**APPLICANT:** Linda Fancellas **PETITION No.:** V-43

## V-43-2017-GIS

Application for Variance
Cobb County (type or print clearly)  Application No. V-43 Hearing Date: 5-10-17
Applicant Unda Fancellas Phone # 404-661-6567 E-mail fanmolly 1 egma, 1.co
Andy Burton Address 2869 Colleton Drive Marietta CA 3  (representative's name, printed)  Address 2869 Colleton Drive Marietta CA 3
andy Bruton Phone # 678-410-6724 mais aby tingget champion.
My commission expires: 6-27-20 Signoth, sorted and find presence of:  Notary Public
Titleholder Linda Fancellas Phone #404-661-6567 E-mail fanmolly 1 cgmail. com
Signature additional signatures, if needed)  Address: 3869 (elle fra Drive Marcha 64 3000)  (street, city, state and signature)
My commission expires: 6-27-20  Signed sealed and delivered presence of:  Notary Public
Present Zoning of Property
Location 7869 (olle-ton Drive Marietta 64 30066 (street address, if applicable; neurest intersection, etc.)
Land Lot(s) 516 District 16 Size of Tract Acre(s)

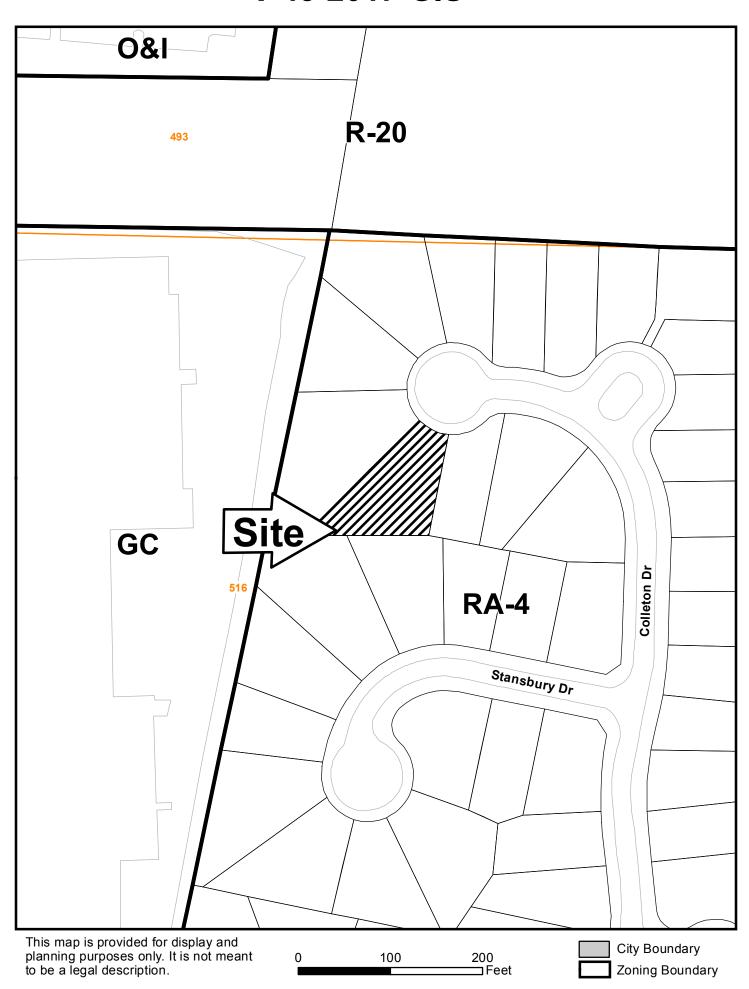
**SITE PLAN REVIEW:** If this variance request is approved, a subdivision plat revision must be recorded prior to the issuance of the certificate of occupancy showing all improvements on the lot along with any approved setback reductions, and referencing the variance case in the standard plat revision note. The surveyor must submit the plat to the Site Plan Review Section, Community Development Agency for review and approval prior to recording. Call 770-528-2147.

**STORMWATER MANAGEMENT:** No adverse stormwater impacts are anticipated. The proposed sunroom will be located on the existing concrete patio. Building permit must be approved by Stormwater Management Division to assure addition does not encroach into adjacent 20 foot drainage easement.
